Victoria on the River, Phase 6, (1934 Commissioners Road East), revised EIS dated December, 2020, received by EEPAC at its February 2021 meeting. Reviewed by S. Hall, S. Levin, and I. Whiteside

Also reviewed were the updated Hydrological Assessment and Water Balance by EXP dated December 3, 2020, and the unrevised Geotechnical Investigation - Slope Assessment from 2017 by EXP

Figure 6

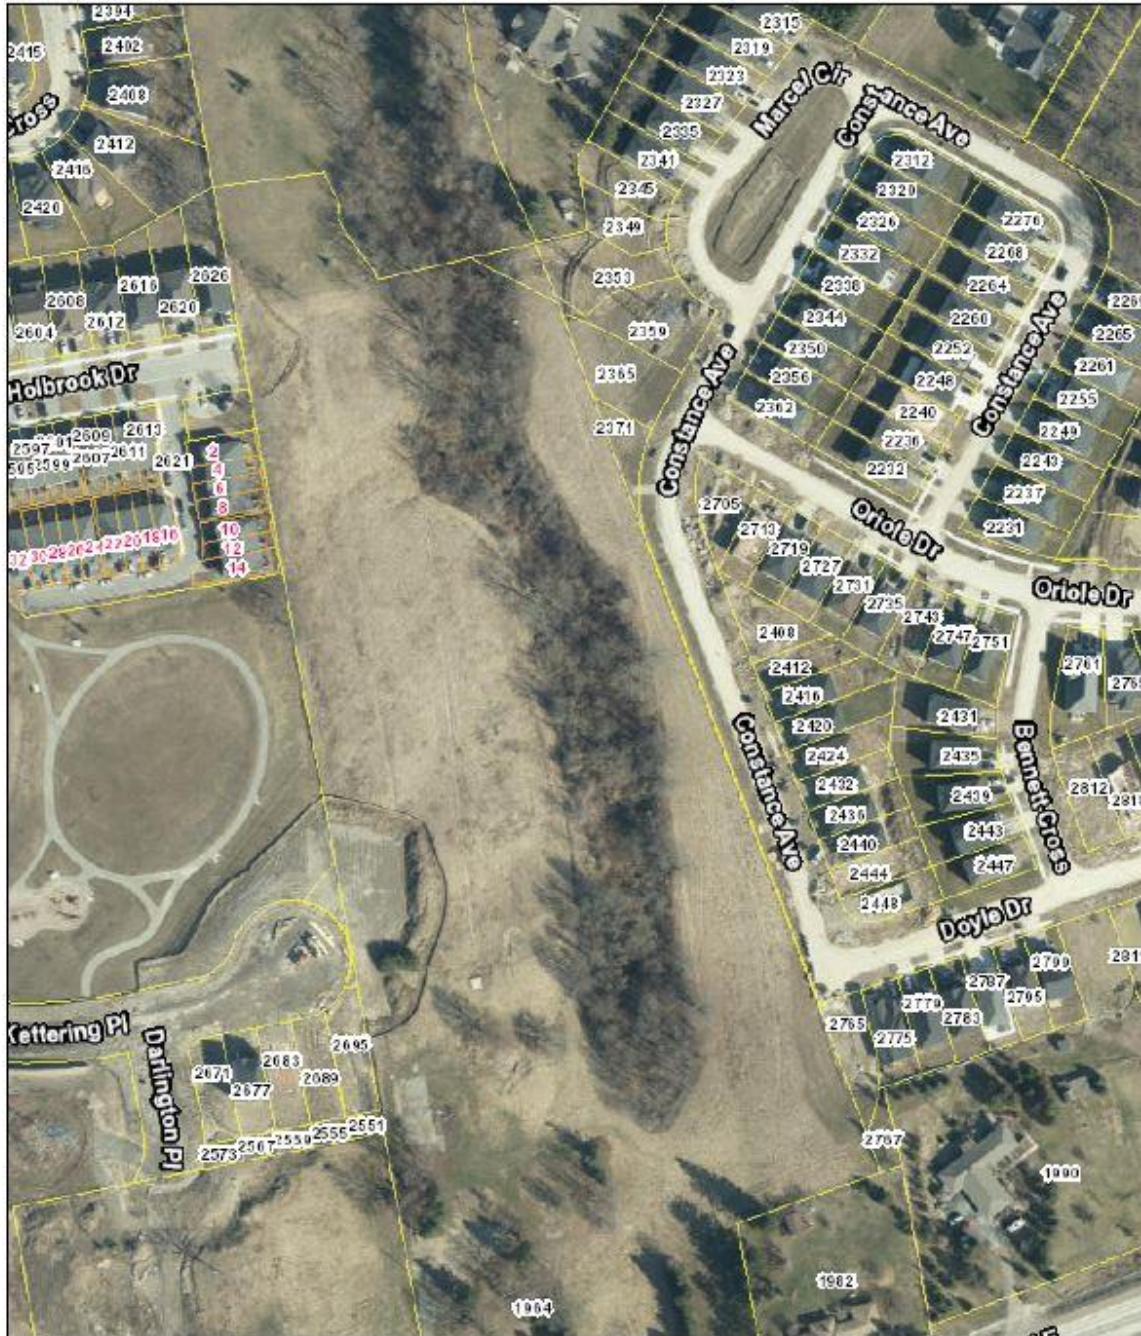
PEDESTRIAN BRIDGE AND TRAIL (see air photos from City web site and Figure 6 from EIS at end of this report)

The EIS report and the Geotechnical Assessment and Slope Stability study were prepared to assess the development's impact on the site, not the footbridge, and so neither study is sufficient for the bridge (see note from page 17 of the Slope Assessment at end of this report). As the city clearly states in their comments, the bridge is "conceptual" at this stage so additional studies will clearly have to be done to support any concrete plans/proposals. EEPAC agrees with the comment from AECOM that an EIS will "likely" be required to specifically address the proposed bridge at the time the works are being planned (page 28 of the Comments). What is clear from the Geotechnical report is that it recommends that "future development generally not occur within the Erosion Hazard Limit identified at the site" (General Comments for Site Work on page 15). If we consider cross-sections E-E' and G-G', and that the foundations for the footbridge need to occur outside of the Erosion Hazard Limit, the foundations will need to be at least 26m + 24m from the edge of the creek (plus the creek width, say 2m). That is, the foundations for the footbridge need to be 50m+ apart (probably closer to 55m?) at minimum to ensure the foundations are constructed outside the Erosion Hazard Limit. Not being 100% sure on the design of the footbridge, but it will be a long one for somewhat marginal benefit, (saves ~400m to walk around the ravine? That's ~3-4 minutes of walking time at a normal rate.) It is also not clear what the limiting set-backs are here – is it the

Erosion Hazard Limit or the Buffer? If it's the Buffer, then obviously the bridge will have to be longer.

The proposed pedestrian pathway will need to meet AODA standards. Hopefully this can be done without pavement as having to mow on both sides will reduce the amount of area re-naturalized which is the only net positive in the net impacts table. Like the UTRCA, EEPAC does not support the trail in the buffer and appreciate that it has been moved to mostly avoid conflict with the buffer.

EEPAC is puzzled why the pathway is needed on the east side of the feature as there is a sidewalk on Constance Avenue which is outside the buffer! The path would end at the new street that will connect Constance to the new development. The path does not continue on the west side of the ravine due to the infiltration galleries at the back of the multi family development. Pedestrians would continue to walk on the sidewalk of the new street, to the next new street (Darlington Pl) to get to the park. We note in the table of responses Dec 2020, city staff said" ... *If the City / Parks Planning would prefer to have the trail overlap with the sidewalk in certain sections, we have no issue with that.*" It is noted that a final decision is going to occur later at "detailed design."

Aerial Photos Selector

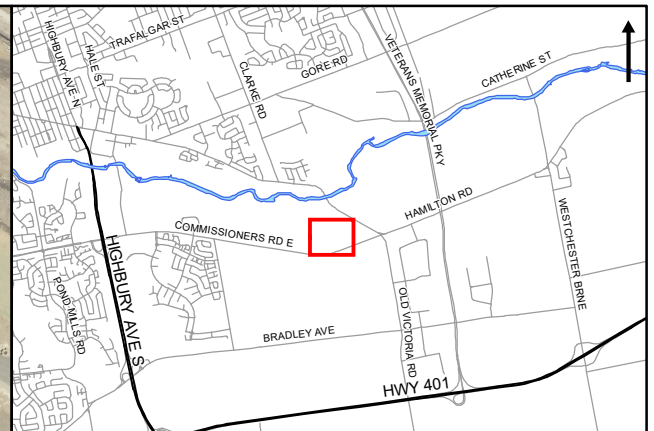
The update should have used currently available air photos that are on the city web site. It would have made things easier to review as the current air photos show the recent construction activity on both sides of the feature.
